CERL Technical Report 99/66
August 1999

Technical Assistance To Supplement Installation of Low NO_x Boilers at the Pentagon Heating and Refrigeration Plant

Figure 2. Windbox corrosion.

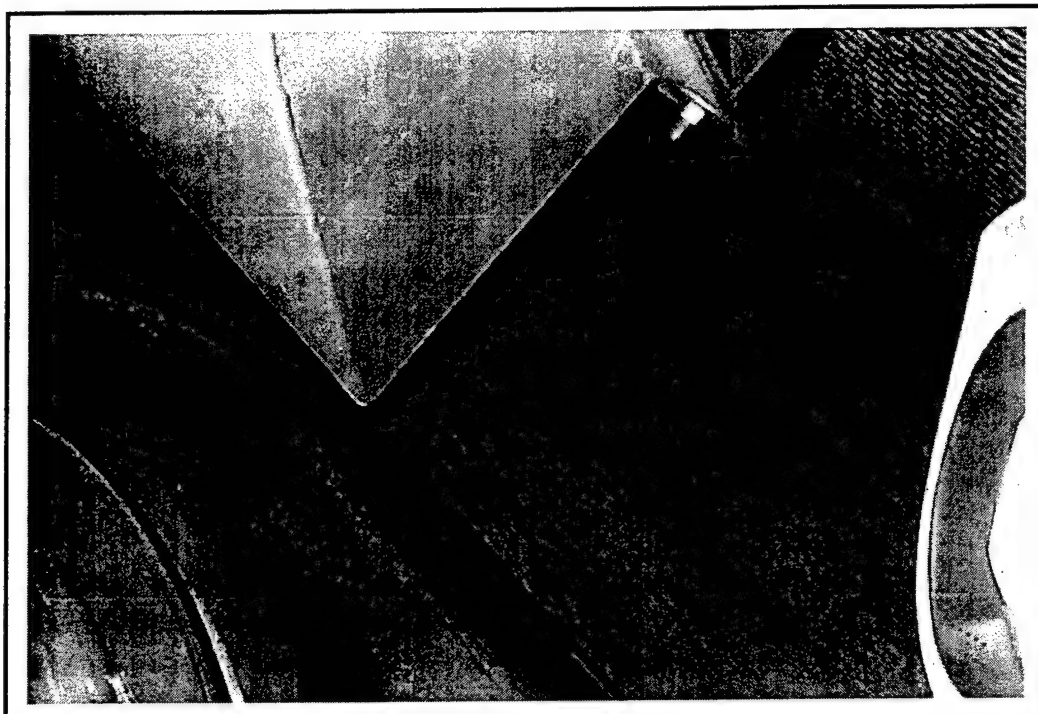
The installer opened up the windbox and furnace on Boiler #5. The windbox and burner are simple in construction. There are no vanes or baffles to ensure thorough mixing of the flue gas prior to entry to the burner throat. Corrosion had already begun to occur where the flue gas entered the windbox (Figure 2). The burner has one set of flat register vanes (Figure 3). The tubes in the windbox did not show any signs of flame impingement although boiler #5 did not have many hours of operation. The laydown chalk makings were still visible. The soot pattern from burning oil can be seen on the left furnace wall (Figure 4).

Figure 9. DCS printout showing boiler No. 4 trends.

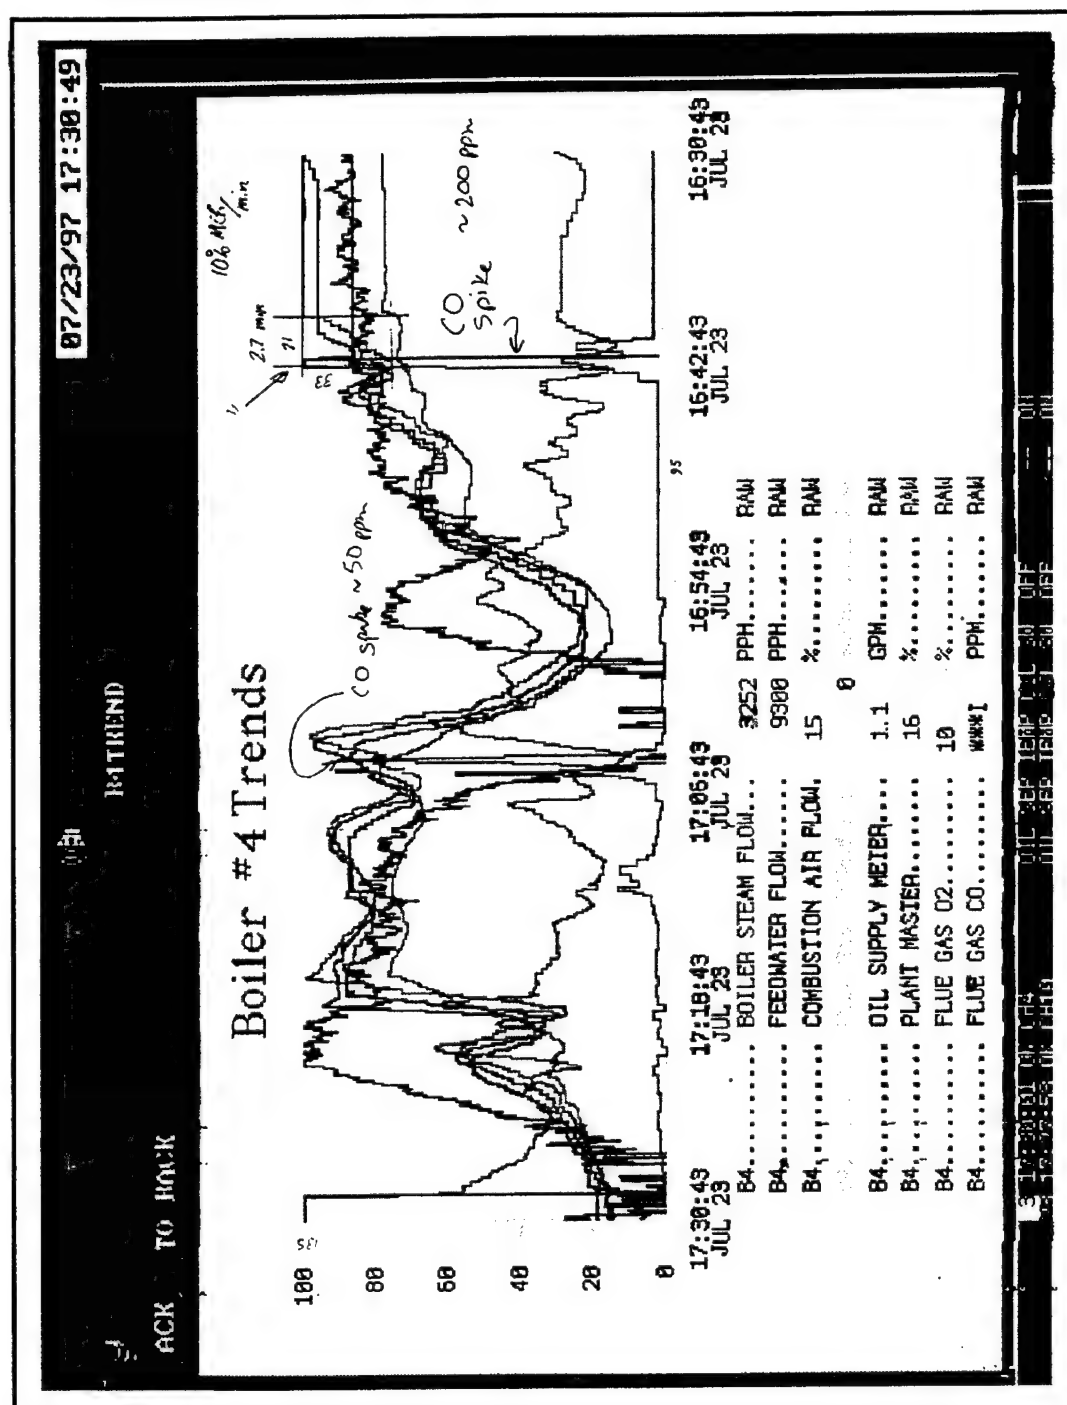
The PRO letter also states that "unexpected carbon monoxide excursions were witnessed 7-9 May 1997 which were possibly due to DCS communications failure." When operating above the turndown limit of 6 to 1, the burners performed satisfactorily. On 23 July 1997, when changing the steam load manually at very high rates (greater than 10 percent Max Continuous Rating [MCR] per minute), there were two CO excursions above 50 PPM when near full load followed by dropping load quickly. (Figure 9 shows the DCS printout.) It was not clear to the team why the excursions occurred under these abnormal operating conditions. Although the load change was abnormal, a parallel metered control system should have been able to handle that change. The control system did respond to the excursion appropriately and increased air to quickly reduce the CO levels. The fuel train may need closer examination to precisely identify the cause of the CO excursion. The control system characteristic curve may need adjustment. For an unknown reason at 16:40 on 23 July, the controls let the fuel valve remain fully open for 30 to 60 seconds after the airflow was being reduced. It appears that the control system ruled that the airflow was so excessive that the fuel did not need to be reduced until the airflow signal had dropped significantly. One factor may be that the fuel oil supply pressure was increased slightly to try to reach full load. The burner did perform safely under normal load transients. However, if the current airflow-metering scheme is used, the team has recommended that the control system characteristic curve be inspected and recalculated.

Figure 10. ASME Code B31.1, Fig 100.1.2(B).

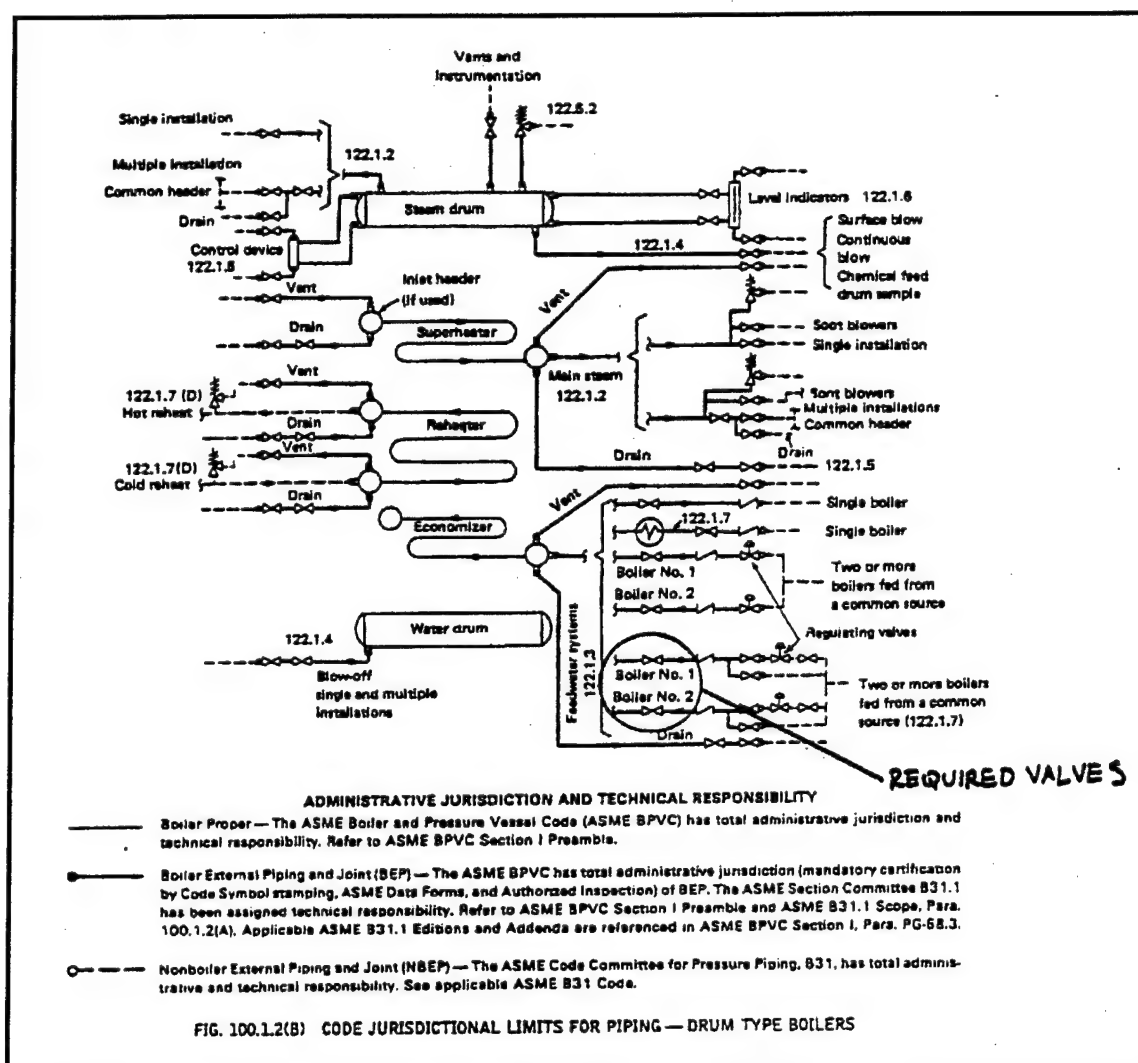
- An ASME Boiler and Pressure Vessel required valve is missing in the feedwater piping. Figure 10 shows ASME Code B31.1, Fig 100.1.2(B). There should be a stop valve isolation valve between the check valve downstream of the feedwater regulation station check valve and the economizer.

Figure 12. Windbox corrosion November 1998.

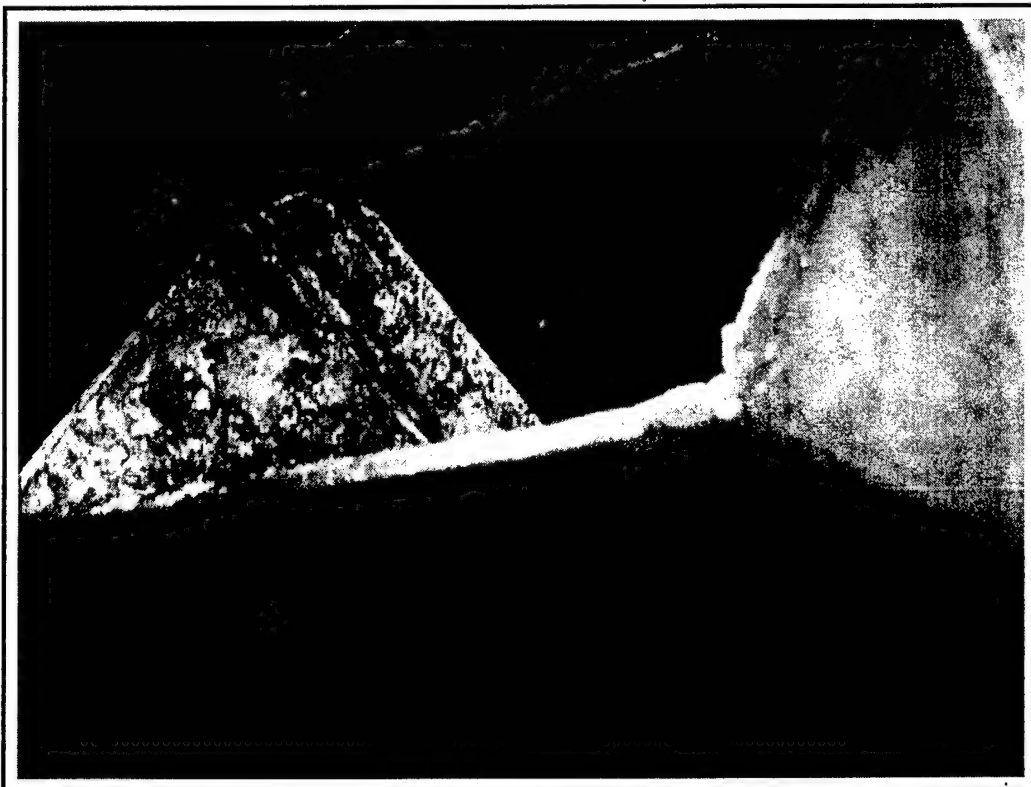
The team inspected the windbox and concurred with PHRP that unacceptable amounts of moisture were being deposited where the flue gas enters the windbox (Figure 12). The moisture has and will continue to cause excessive corrosion on the recirculated flue gas dampers, gas line in the windbox, and the gas ring. The corrosion will greatly shorten the life the burner. The team can investigate the life expectancy of the burner ring. Vincent Hock at CERL can provide corrosion expertise support. The team can also provide a list of burner manufacturers who have successfully installed low NOx burners at DOD sites if desired.
